To: Robb Klauk, Land Design
From: Pat O’Mahony, Associate Planner; 910-341-3260
CC: File;
Date: 3/4/2024
Re: Dave & Busters TRC Rev. 1

Project Name: Mayfaire Dave & Buster's
Formal TRC Date: 03/07/2024
Reviewer: Eric Seidel, PE
Department: Engineering – Plan Review Section

Project: Dave & Buster's Mayfaire
TRC Meeting Date: 3/7/2024
Reviewer: Anna Reh-Gingerich
Department: Stormwater

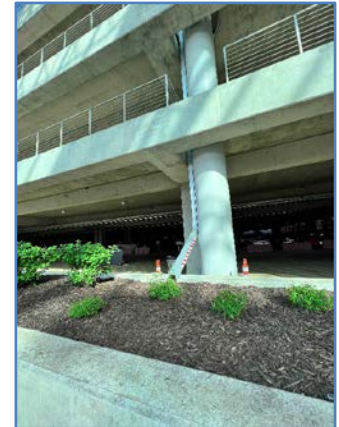
3. Consider green roofs, rainwater harvesting, or redirecting some downspouts from the buildings into stormwater planter boxes (as shown on the right) to help mitigate some of the roof runoff before draining to the drainage system:
